Response to Interactive comment RC2 on gi-2021-30 - "Contributors to Fluxgate Magnetic Noise in Permalloy Foils Including a Potential New Copper Alloy Regime" by David M. Miles et al. by Anonymous Referee #2 on 12 Dec 2021

Figure 2: Histograms of noise distribution for 20 cores. Bin 16 pT/√Hz includes cores from both histograms

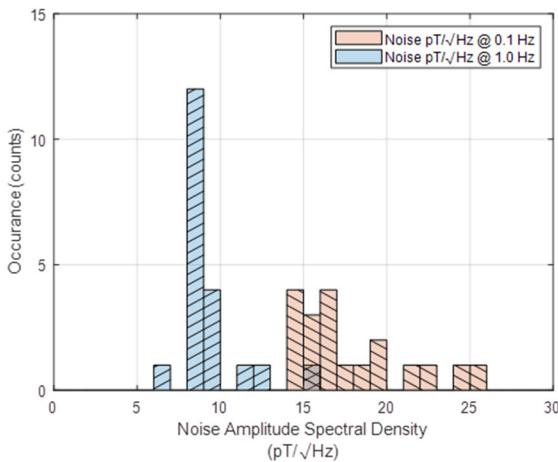
Figure 13 shows a dark brown bar inw the range of 15÷16 pT/√Hz. However, there is no explanation for this color in the figure.

*Change made. The 'brown bar' resulted from the overlap of the 0.1 Hz and 1.0 Hz spectra. The figure has been regenerated with semi-transparent bars and hash lines for clarity. The caption has been amended accordingly.*
